FILE P.I. No. 0007221, Candler County
CSSTP-0007-00(221)
Drainage Improvements along Vertia Street
In Metter

SUBJECT APPROVED REVISED PROJECT CONCEPT REPORT

REVISED PROJECT CONCEPT REPORT

1. Sketch Map
2. Cost Estimate
3. Revised Proposed Typical

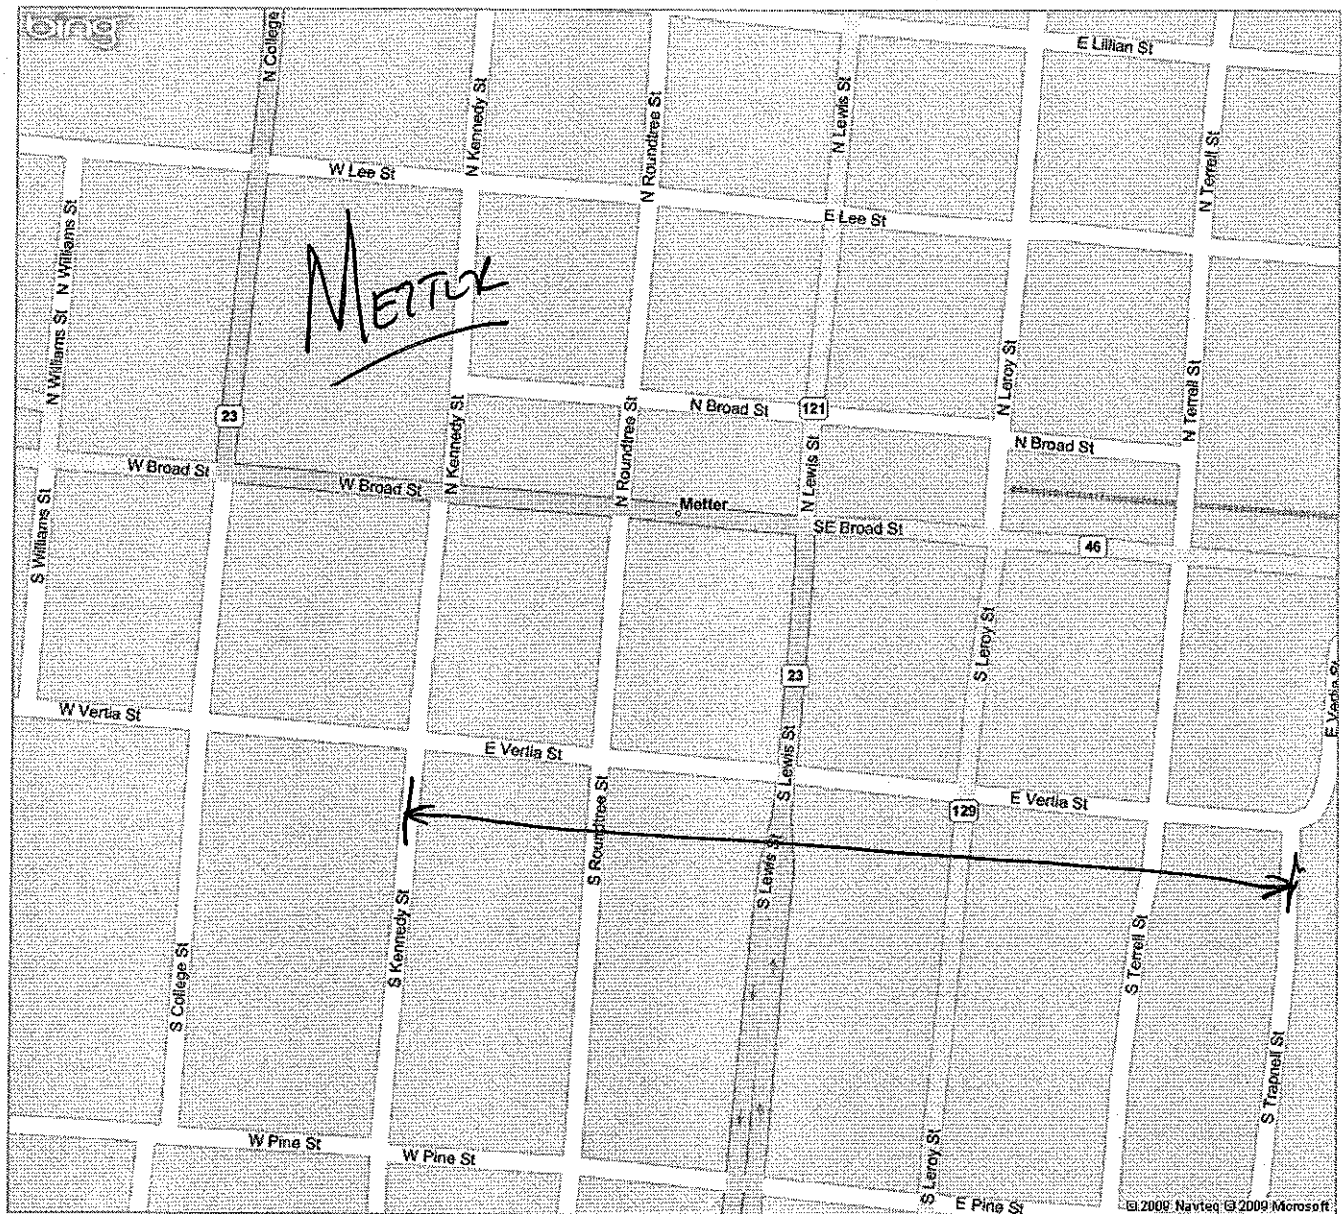
The drainage structure revision entails the combination of the original Alternative (1) and Alternative (2) from the approved Concept Report. This will incorporate various points of two longitudinal drainage systems on the north and south sides of Vertia Street outfalling to an existing ditch. The ultimate discharge will be accommodated by the ditch flowing into a proposed Triple 6' X 4' Box Culvert under South Trapnell Street. The project description and proposed structures are to be revised per features as listed below.

- Typical Section: Vertia Street (CS 559) will continue to use the existing lane widths throughout the length of the project. Only at locations of drainage construction (catch basin inlets, longitudinal and cross drain piping) that warrant roadway surface reconstruction will new asphalt pavement/full depth conditions apply. The existing curb and gutter will be replaced and additional curb and gutter will be constructed where existing conditions warrant. Sidewalks will be replaced only at existing locations and where drainage construction applies.

- Project Termini: This is a special consideration project in which the existing drainage system is not sufficient to handle the drainage for this area. The project is located on CS 559/Vertia Street. The project extends on Vertia Street from the intersection of CS 577/Kennedy Street to CS 558/Trapnell St. in Metter, Candler County. Therefore, the project description should be revised to state: "CS 559/Vertia St. fm CS 577/Kennedy St. to CS 558/S. Trapnell St. in Metter". The project length will be revised to 0.40 miles. The beginning and ending termini for CS 559 (Vertia St.) are MP 0.31 and MP 0.71 respectively. The drainage structure revision entails the combination of the original Alternative (1) and Alternative (2) from the approved Concept Report. This will incorporate various points of two longitudinal drainage systems on the north and south sides of Vertia Street outfalling to an existing ditch. The ultimate discharge will be accommodated by the ditch flowing into a proposed Triple 6' X 4' Box Culvert under South Trapnell Street.
